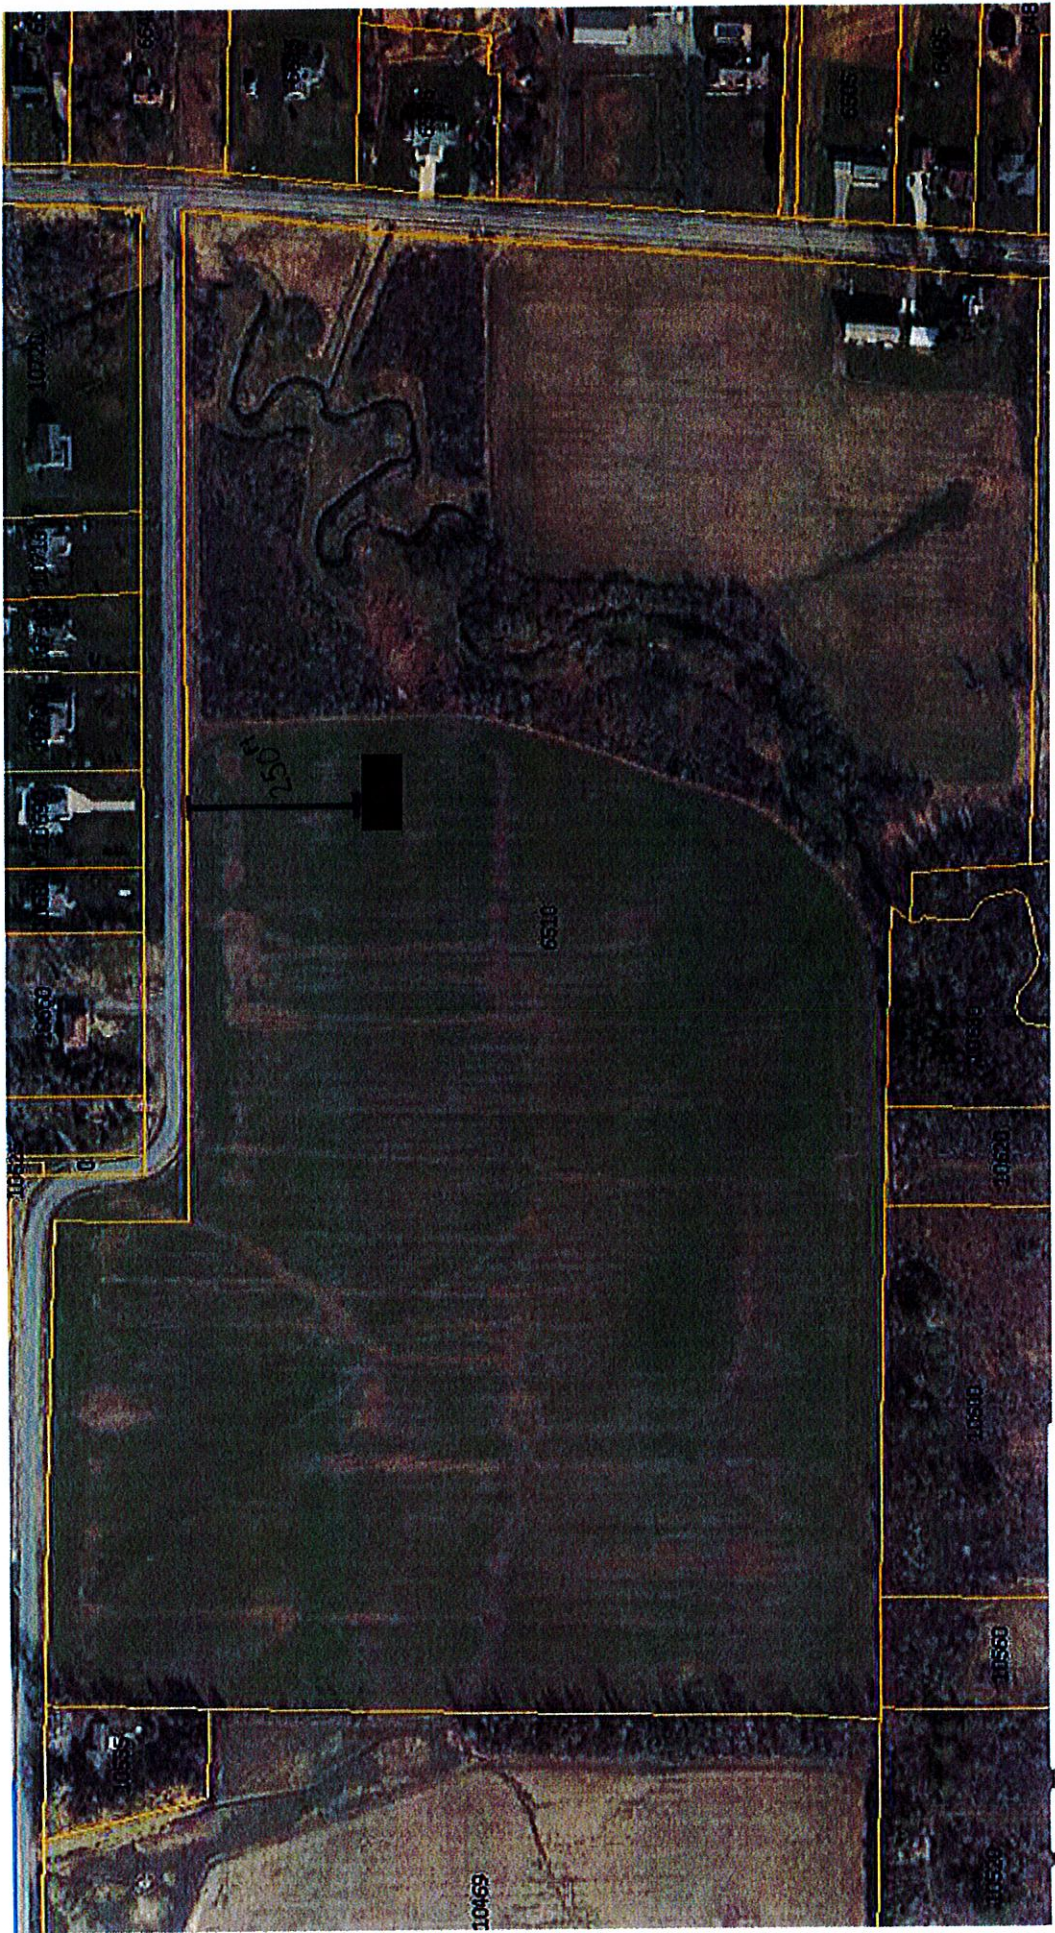
Proposed single-family home fronting Croop Road.

The front yard setback along Croop Road is proposed to be 250'.

The established front yard setback along Croop Road within 500', excluding parcels that previously received variances, is 55'.

6510 Salt Road

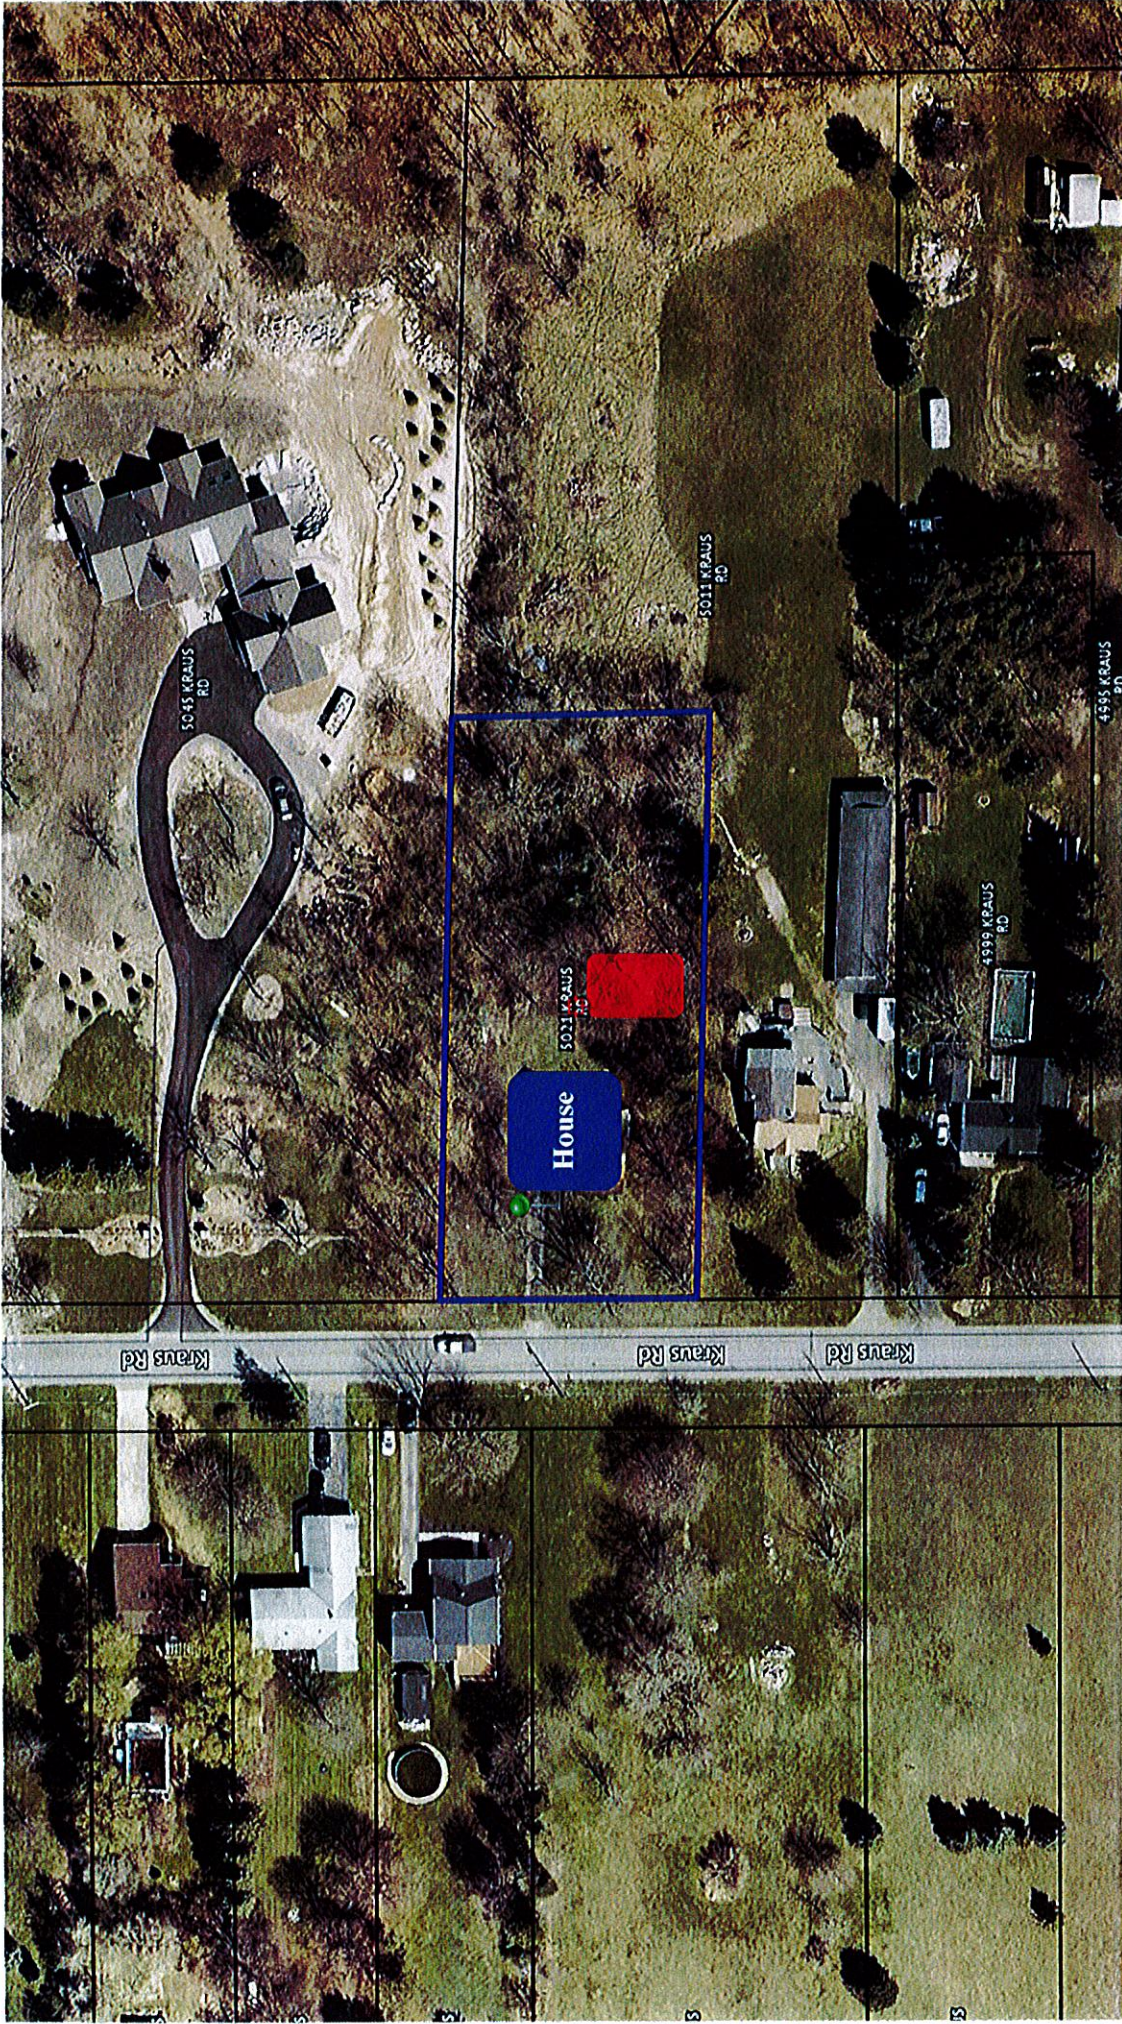
Proposed 1,008 sq.ft. (42' x 24') detached accessory structure.

The maximum allowable square footage for a detached accessory structure when an attached garage exists is 200 sq.ft.

A 808 sq.ft. variance is requested.

5472 Martha's Vineyard

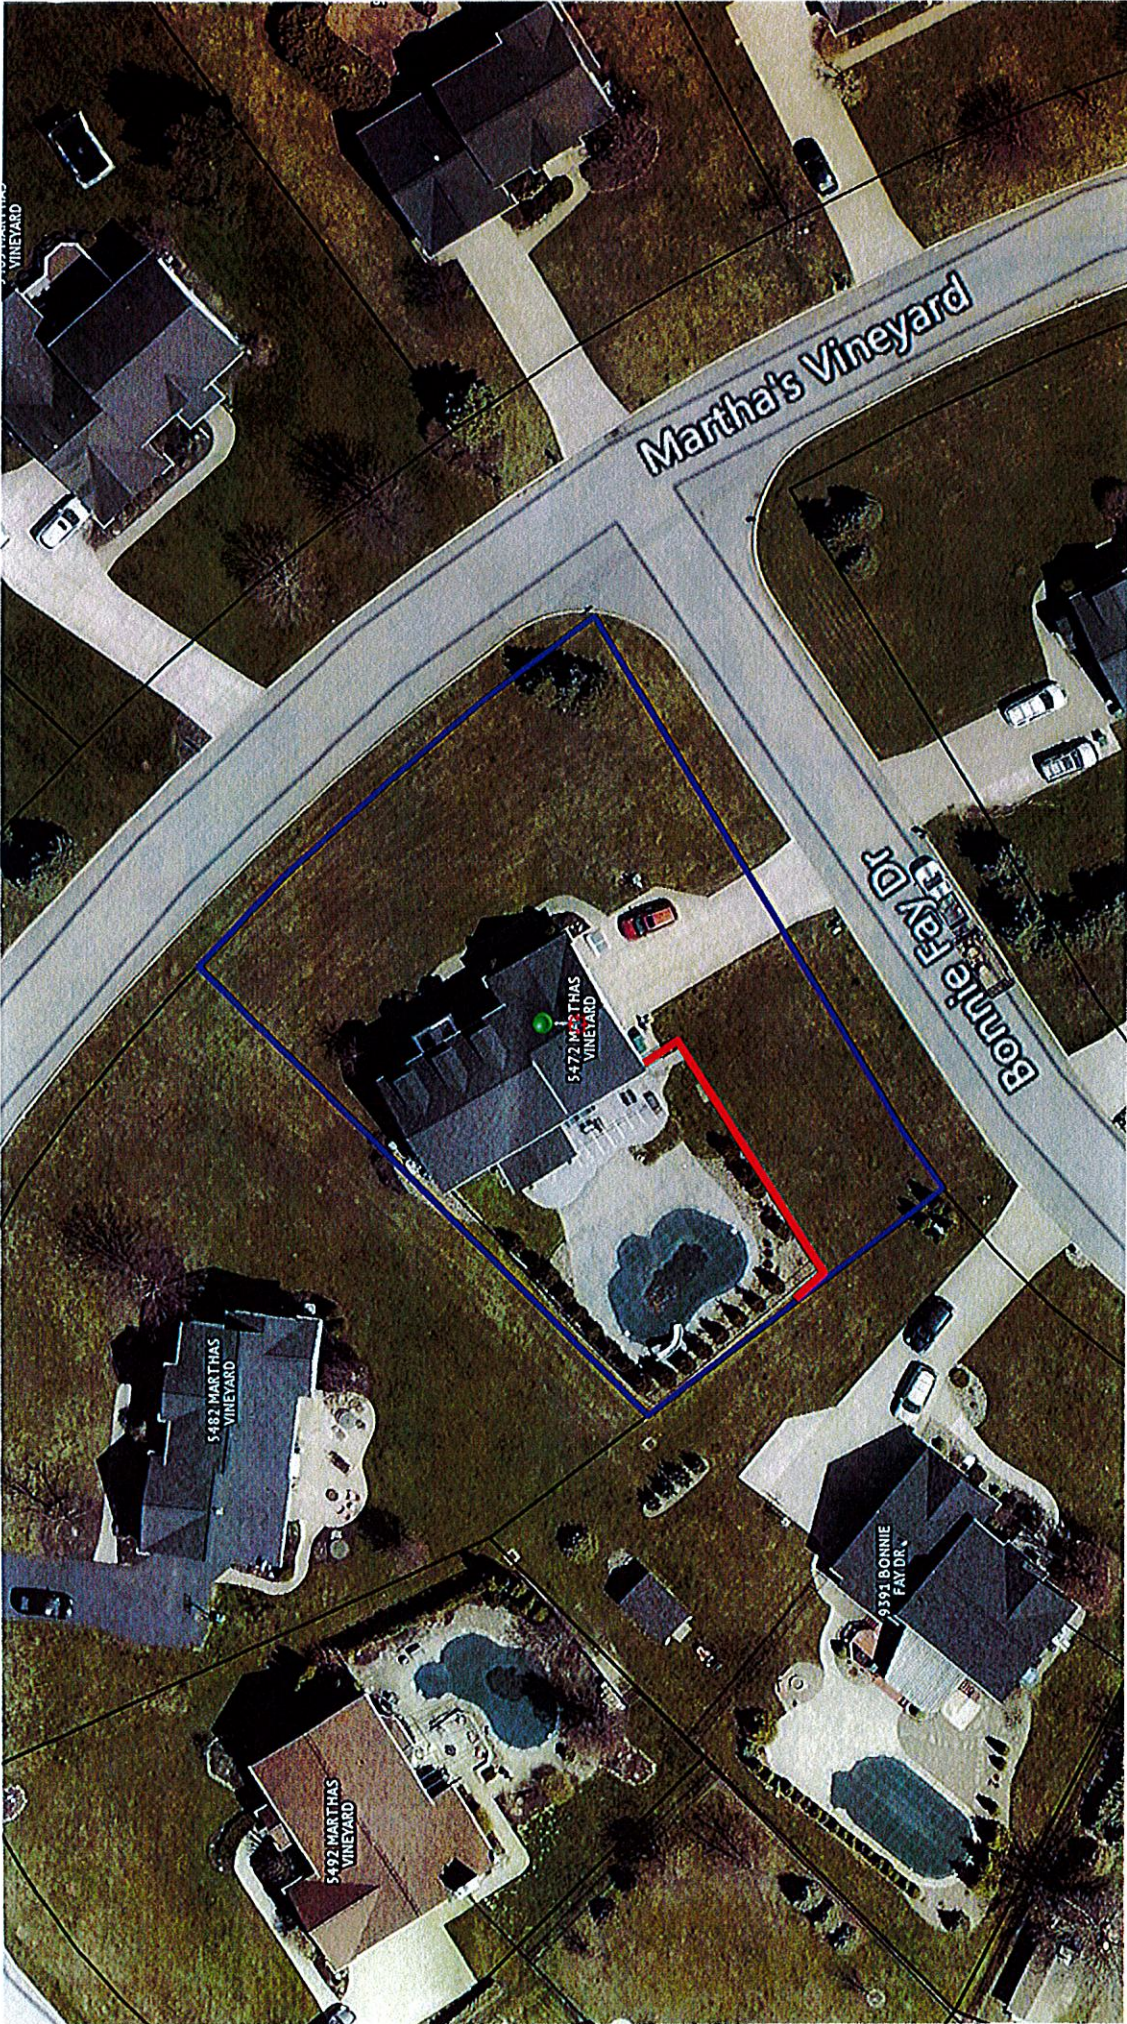
Proposed 6' fence to be located within front yard. The maximum allowed height for a fence extending into the front yard is 4'. A 2' variance is requested.

Note: A corner lot shall be considered to have two front yards from the public road right-of-way to the closest point of the principal structure.

8960 The Fairways

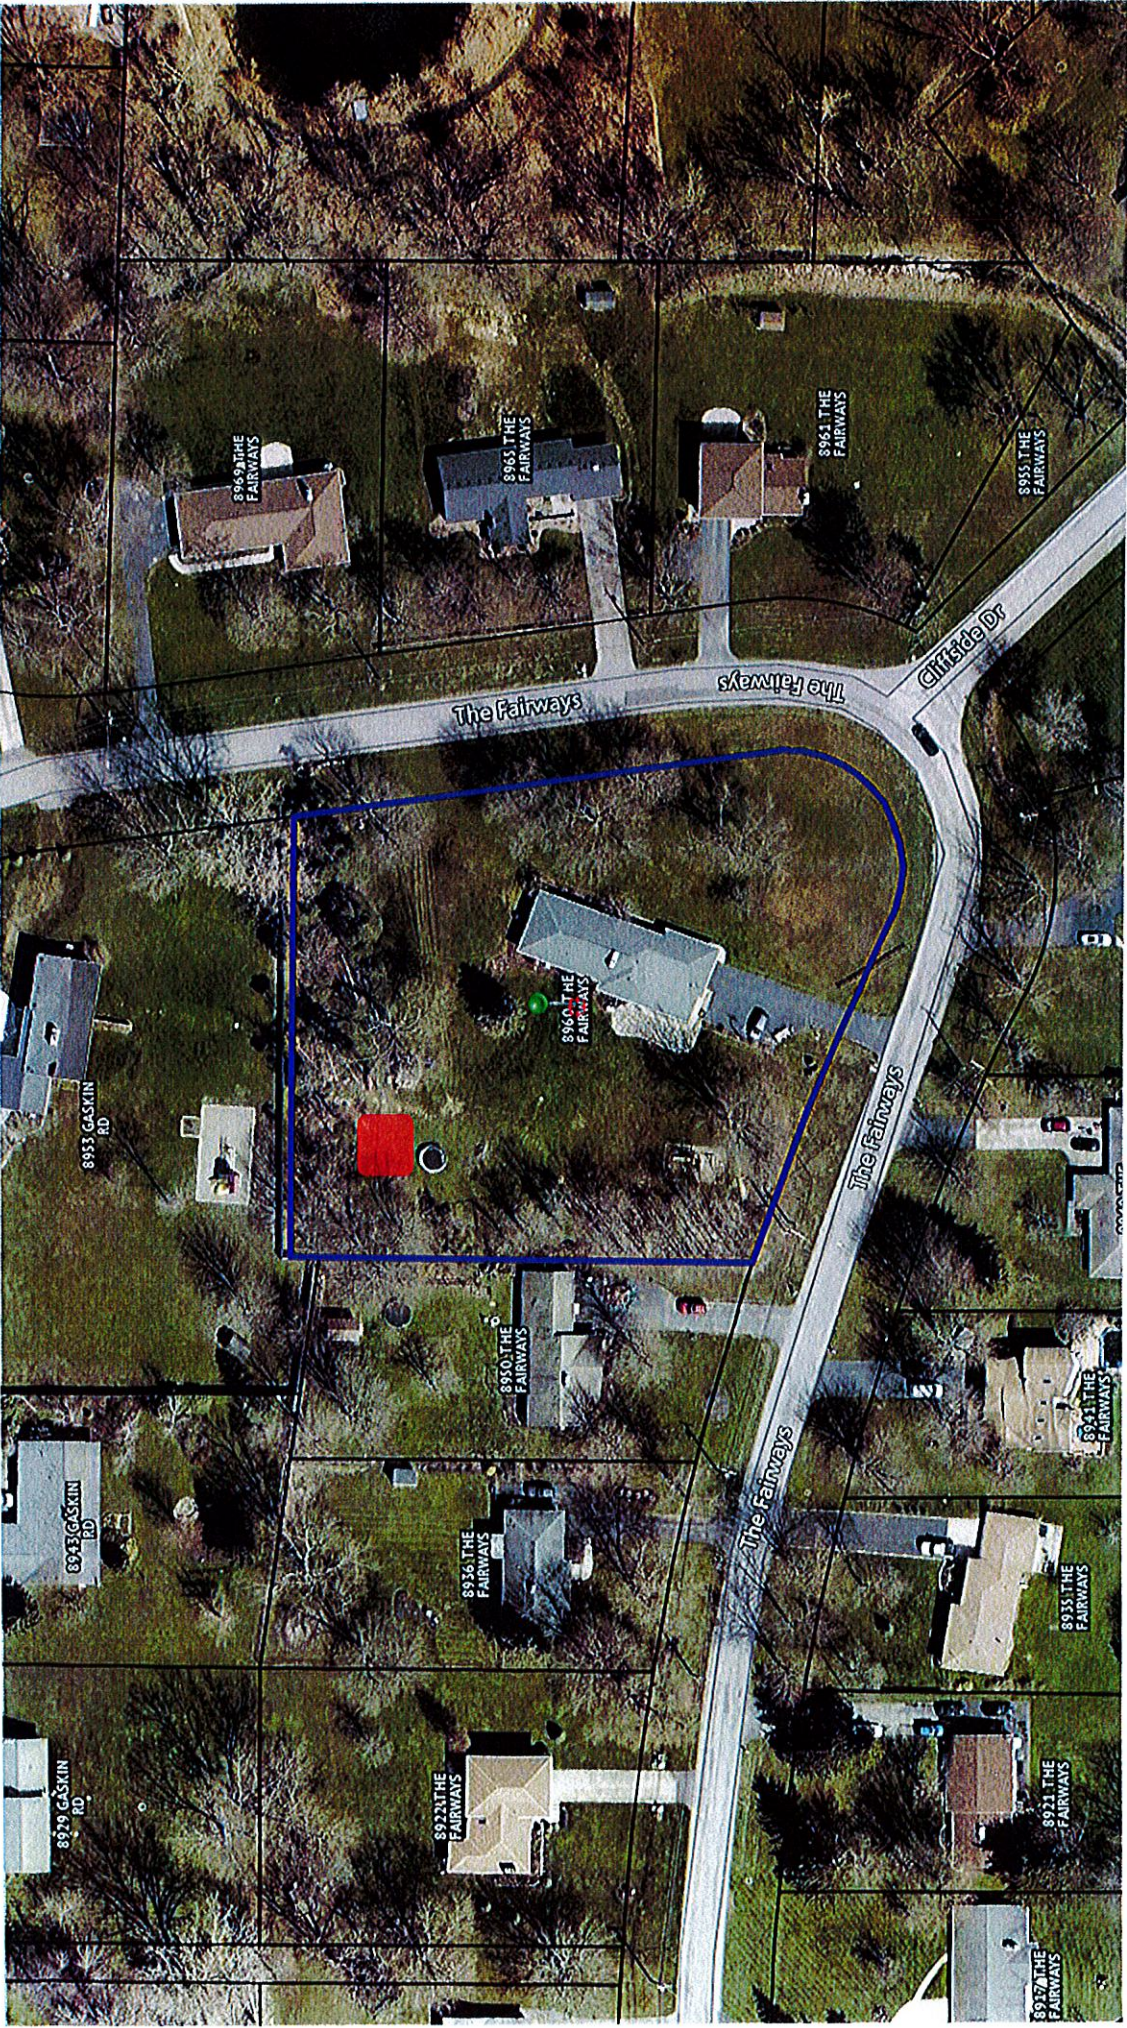
Proposed 560 sq.ft. detached accessory structure (shed). The maximum allowable square footage for a detached accessory structure when an attached garage exists is 200 sq.ft. A 360 sq.ft. variance is requested.

Proposed detached accessory structure with metal siding. Accessory structures with a total area exceeding 400 sq.ft. shall be constructed using materials and features similar to the principal structure.

9762 Cobblestone Drive

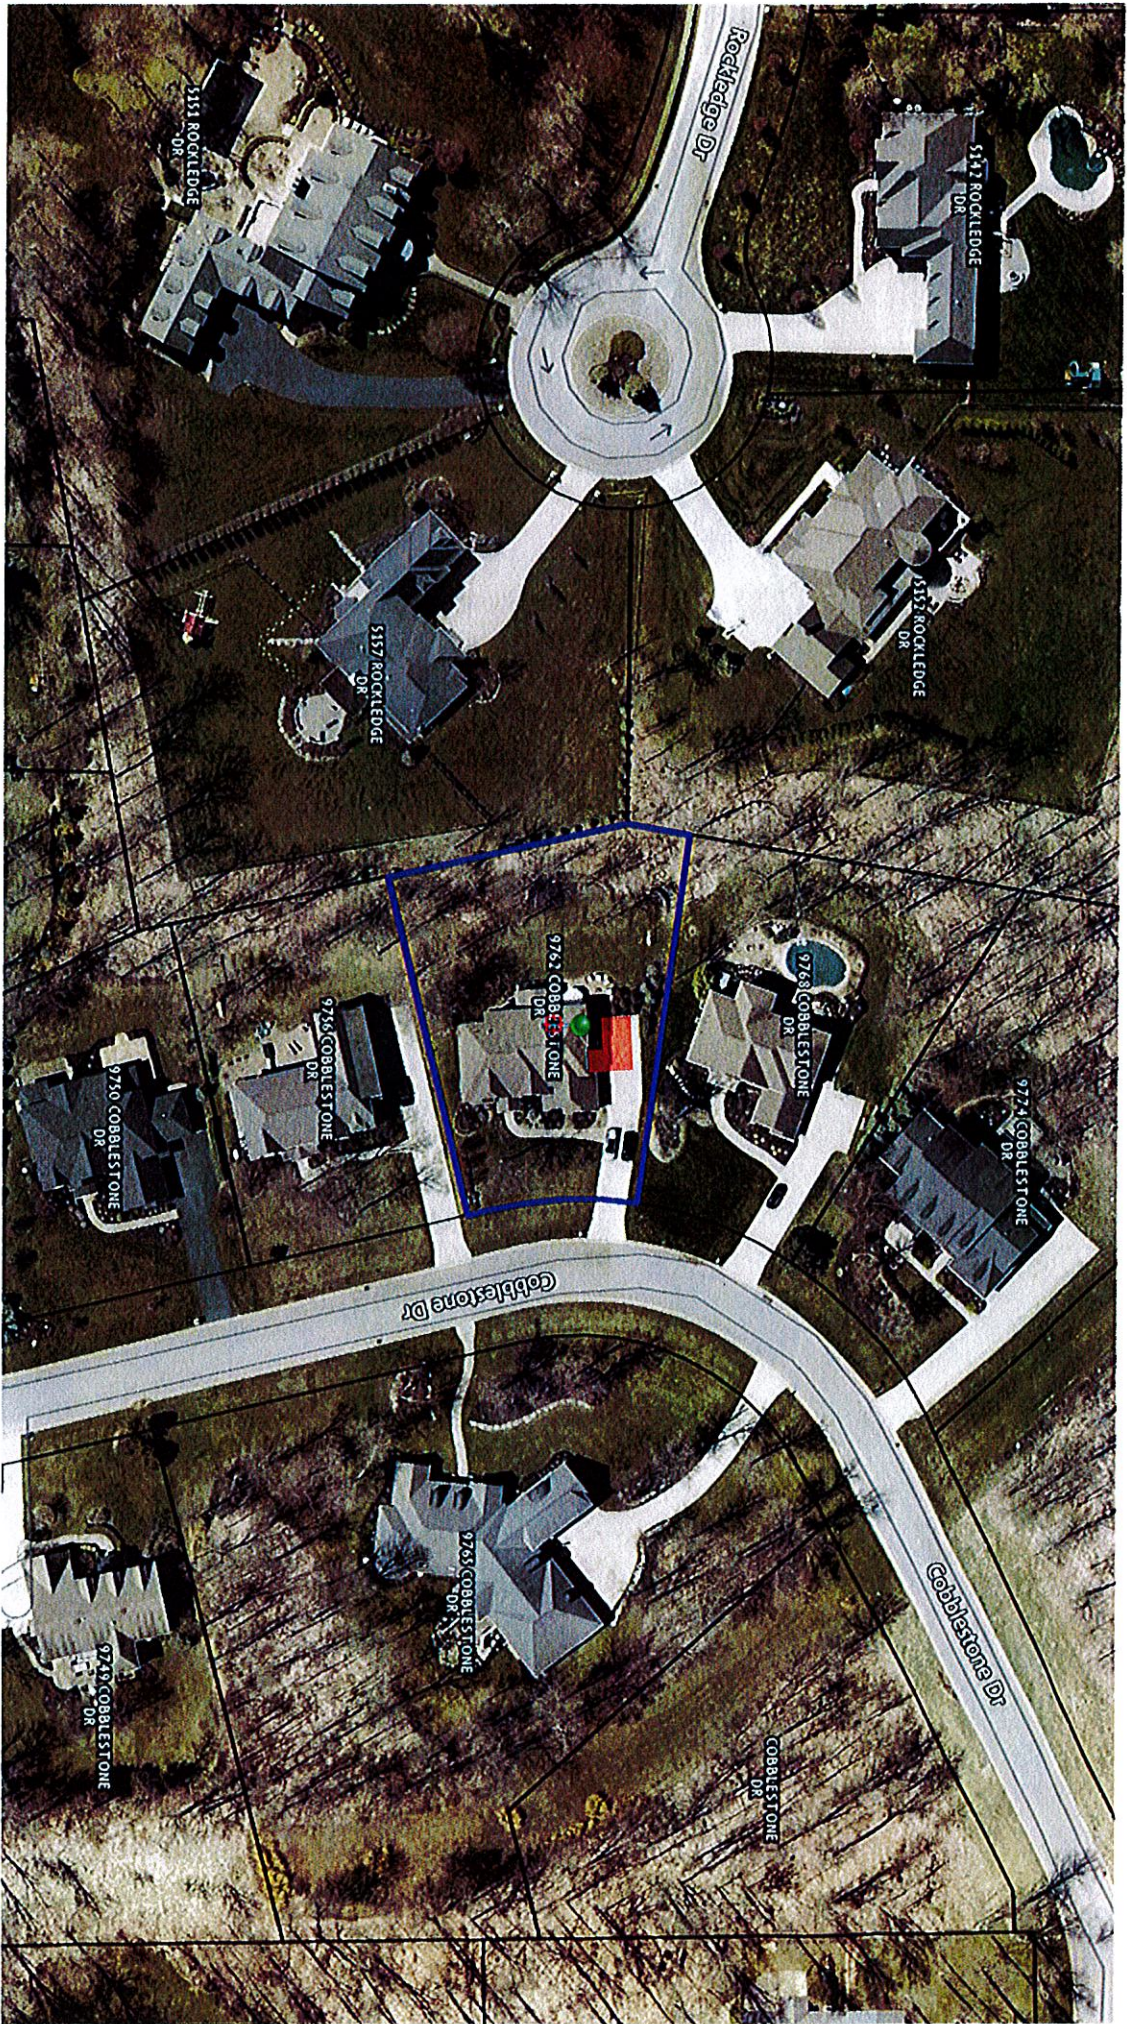
Proposed attached accessory structure (garage) addition totaling 327 sq. ft.

The proposed total square footage of the attached accessory structures would be 1,087 sq. ft.
